# SERVICE LETTER SL29 66-12700

1. **Service Letter No.:** SL29 66-12700
2. **Release Date:** 05/22/2017
3. **Reason for Change:** Installer request to lengthen hydraulic lines to reach outside of the intercostal. Length increase for fit of 66-12731 hoses.
4. **Part/Assembly No.:** ECN 1161 Drawing 66-12700
5. **Float Model Affected:** 6650
6. **Disposition of Product in Field:** Optional (Required if Flexible Hoses Used).
7. **Approval:** All information provided is in accordance with approved data.
8. **Corrective Action:** Relocate the connection points of the internal lines closer to the intercostal of the aircraft where it is more accessible for mechanics.
9. **Time Required:** Under 4 hours
10. **Payments:** None. Call (208) 448-0400 FOR Parts Department.

Figure 1: Hydraulic Tube # 17 (9) with Union, Flared Tube (40)

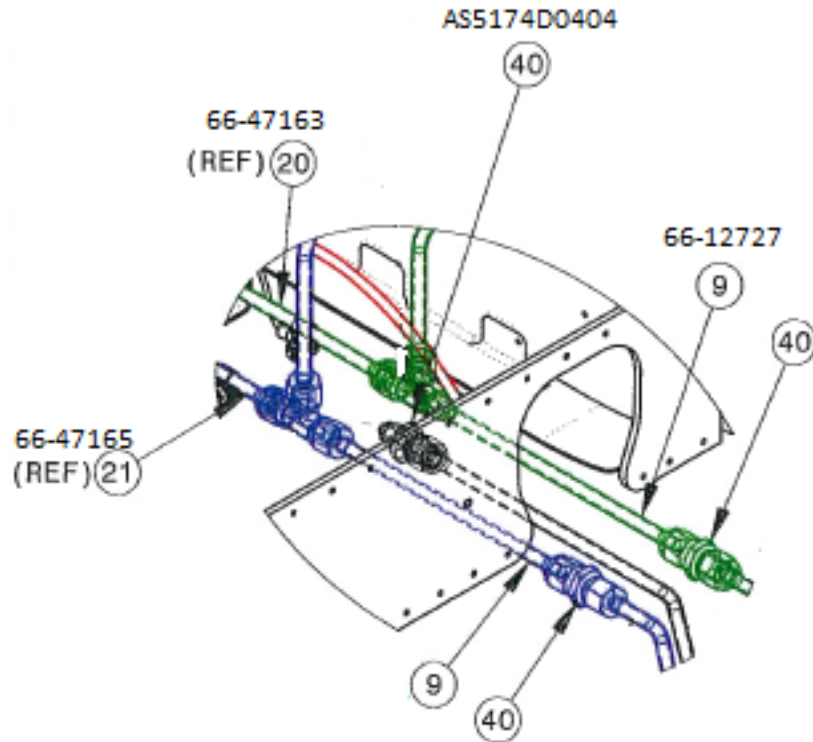
1. 66-12700: Add 66-12727 (2X) (Figure 1) and AS5174D0404 Unions (Figures 1 and 2) (2X) to RHS hydraulics exit.
2. 66-12727: New
3. 66-47163: Length 36.00 was 33.63.
4. 66-47165: Length 36.00 was 32.75
5. Verify length and/or replace existing 66-47163 and 66-47165 tube assemblies with Rev A, longer versions when changing 66-12731 flexible hose assemblies. (Ref Service Letter SL66-12700. Add 66-12727.
